ADDENDUM NUMBER: Three (3)

TITLE: 1412039648 (IFB) Steel Poles for 69kV Circuit 691-693 Structure Replacement Project

DOUBLE DEADEND
VANG FOR
INSULATORS/SHIELD/GUYS

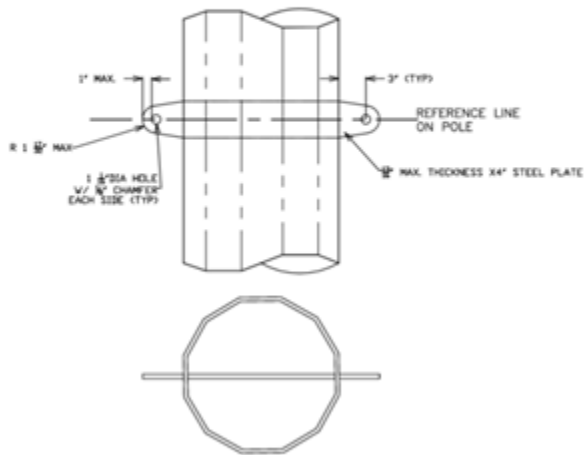
1. JEA adds "1412039648 Addendum 3"
2. JEA adds "1412039648 REVISED (2) Solicitation"
3. Bid due date has been extended to October 7, 2025
4. **QUESTION:** For bid item #5, "STR17 (1) additional distribution arm"
 - Can you please provide a drawing/spec for the "distribution arm bracket" and "arm"?

ANSWER: STR 17 does not have a distribution arm. STR 13 does. The dimensions specified for the arm are provided on SH. 1. It is a 9.5 FT arm with double dead-end through vangs at the locations indicated. The bracket is to be designed by the vendor. Bid Item No. 5 should be revised to state "STR 13 - One (1) additional distribution arm for O&M."
